RESPONSE TO COMMENTS

City of Miami Beach,
Wachovia – Alton Road
Response to Building Dept. Cmts.
Page 2 of 4

WACHOVIA - ALTON ROAD BRANCH
1901 ALTON ROAD
MIAMI BEACH, FLORIDA

DESCRIPTION OF WORK:	Construction of New Exterior ADA Ramp; Relocation of ATM & AHD Equipment; Minor Interior Remodel to Create a New ATM Room.
BUILDING CODES:	FLORIDA BUILDING CODE, 2004 EDITION 2004 FLORIDA FIRE PREVENTION CODE NFPA 101, LIFE SAFETY CODE, 2003 EDITION
BUILDING TYPE:	TYPE IIIB
CLASSIFICATION OF WORK:	ALTERATION - LEVEL 2
OCCUPANCY TYPE:	BUSINESS
OVERALL EXISTING BUILDING SQUARE FOOTAGE:	6,085 SF
OCCUPANT LOAD:	1 PERSON/100 S.F. GROSS (6,085 SF/100 SF = 61 PEOPLE)

A1.0

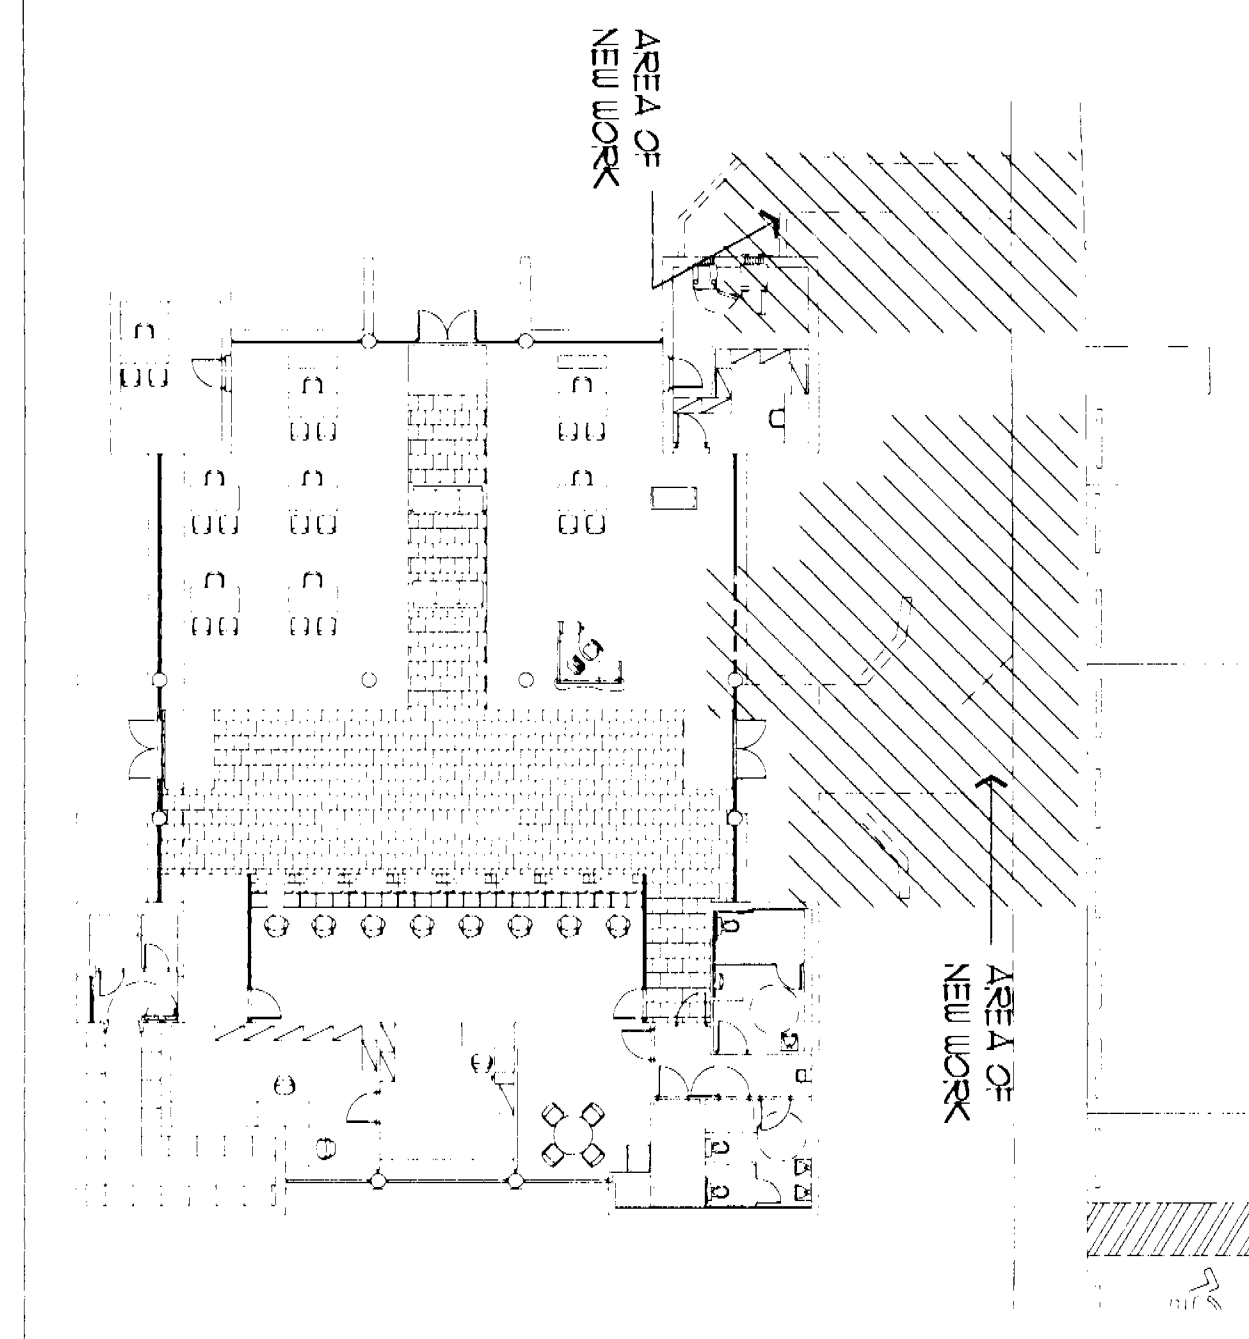
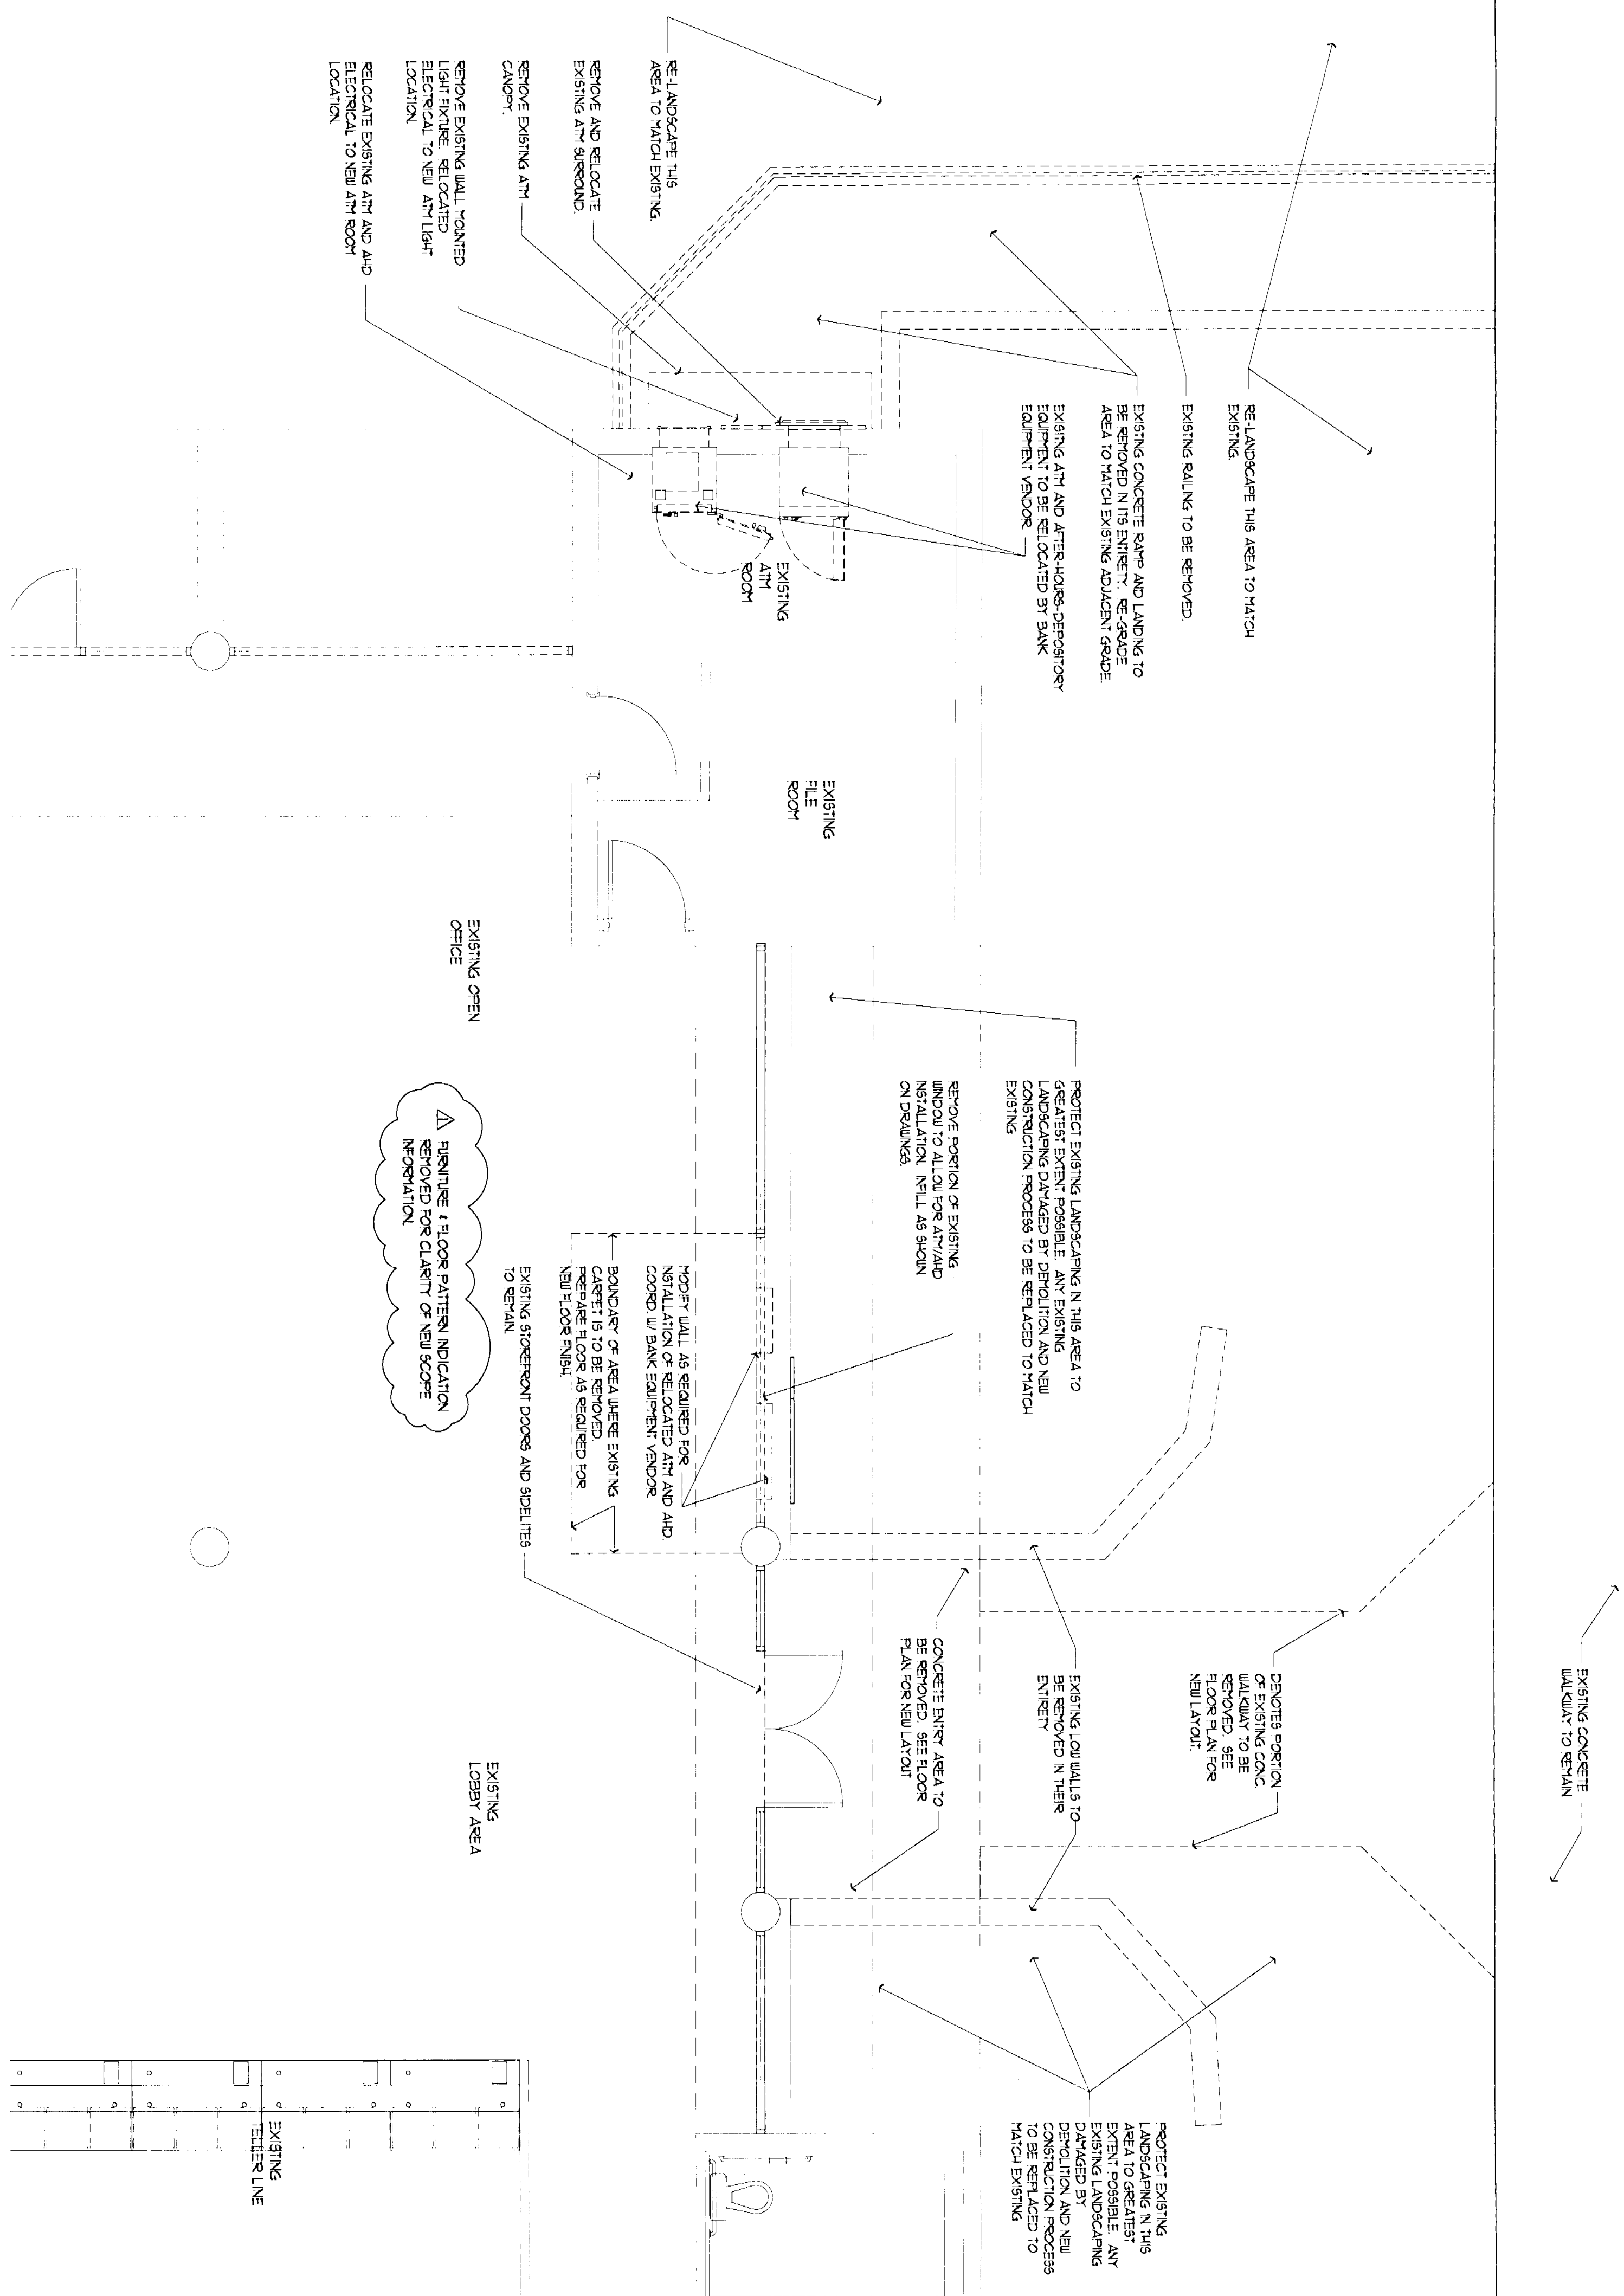
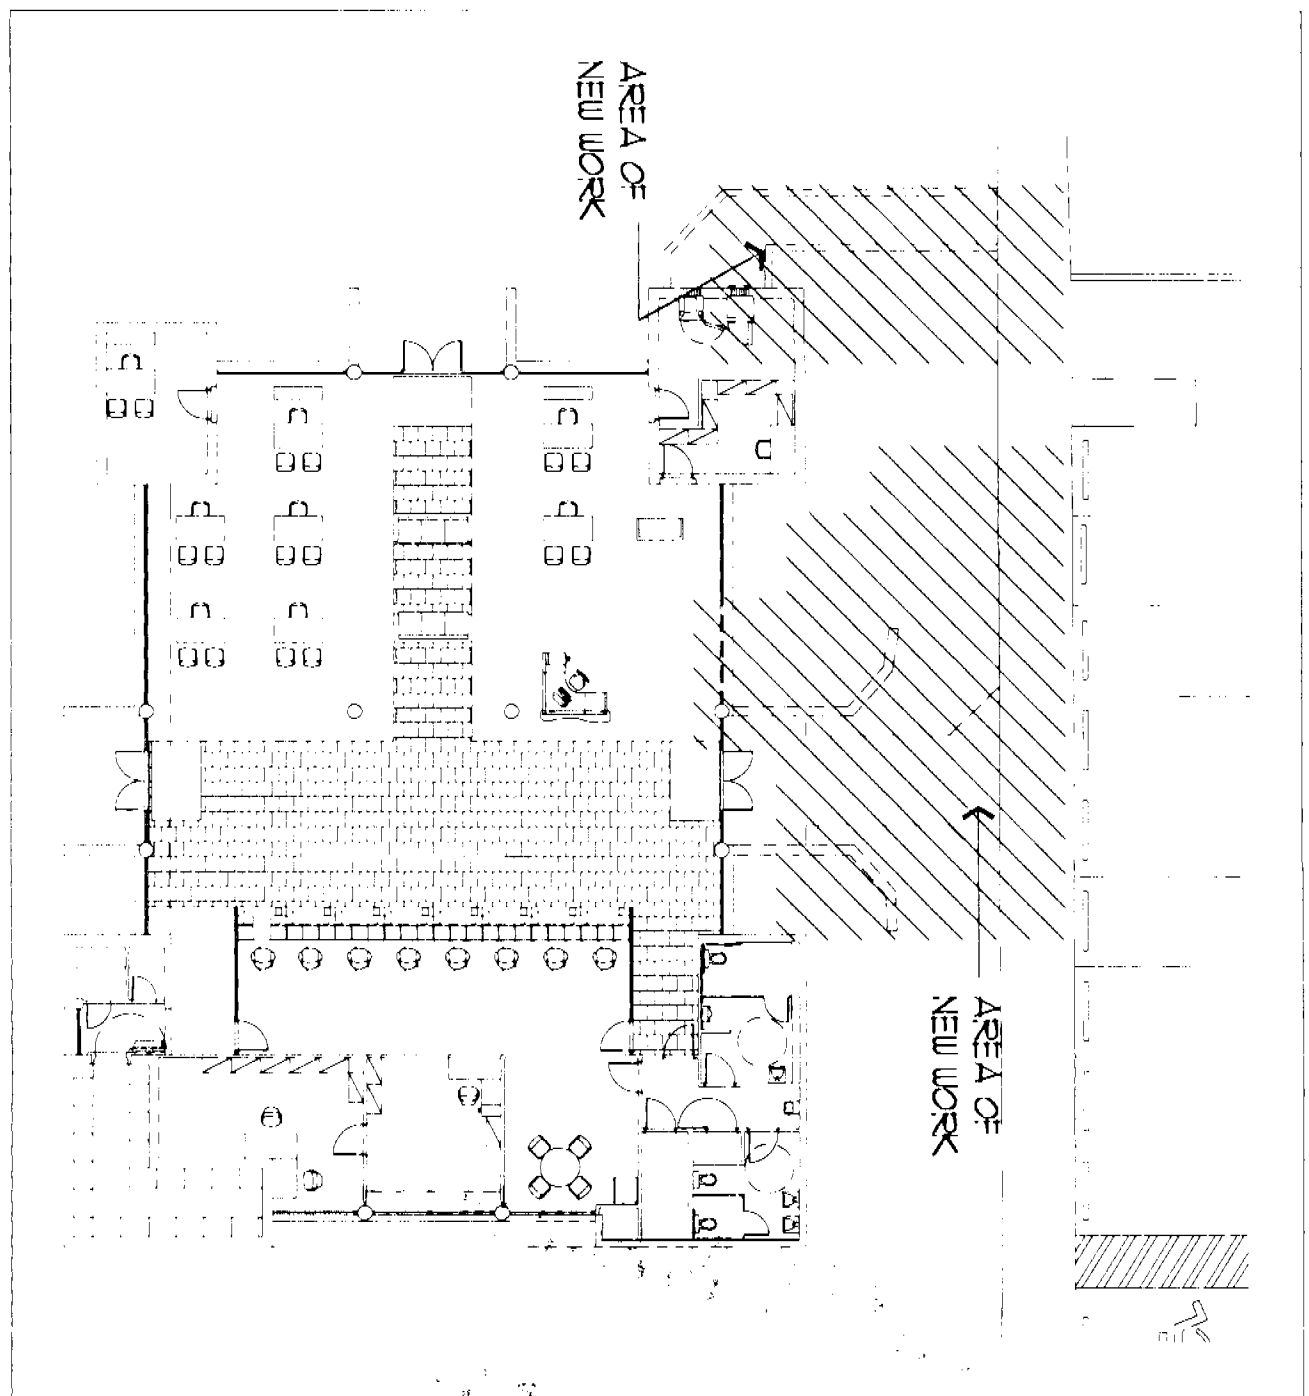
Show and elevation at each surface.

Elevation marks have been placed on the Floor Plan. Refer to revised Sheet A1.0 for the information requested.

**ELECTRICAL
PARTIAL FLOOR PLAN**

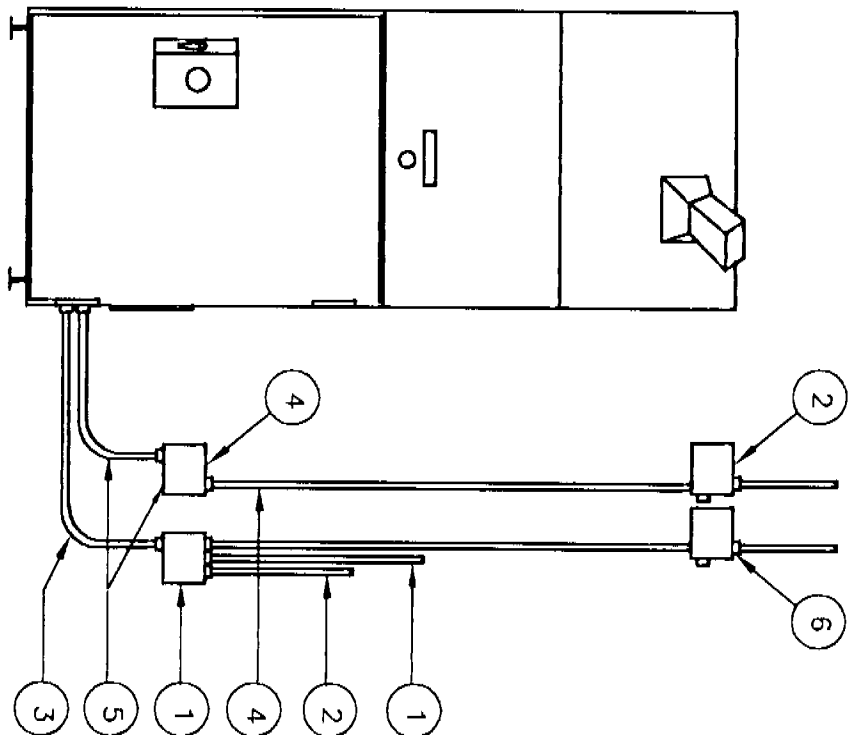
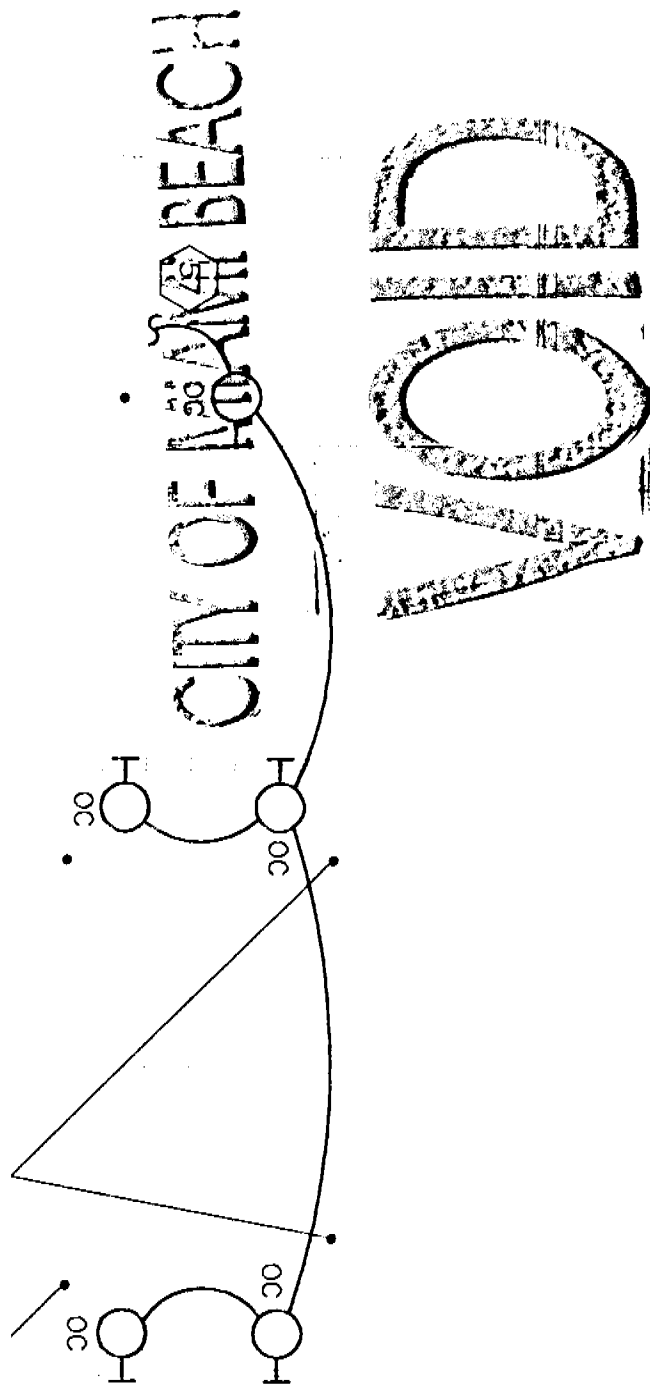
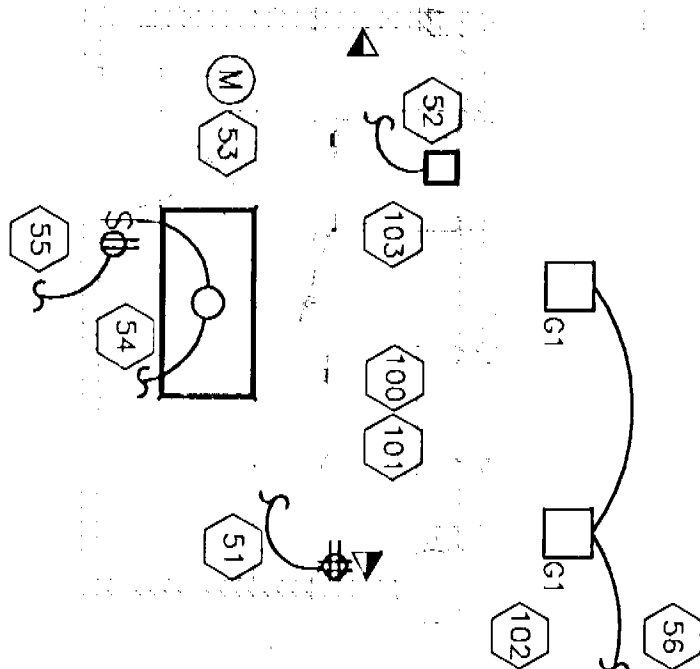
Comment 2: Circuit numbers and existing load on circuits as well as load to be added to circuits.

Response: The circuit numbers and loads have been added to the drawings. See revised notes on Drawing E0.1, dated Revision 1, 12/12/07. See Revised Floor Plan on Drawing E1.0, dated Revision 1, 12/12/07.
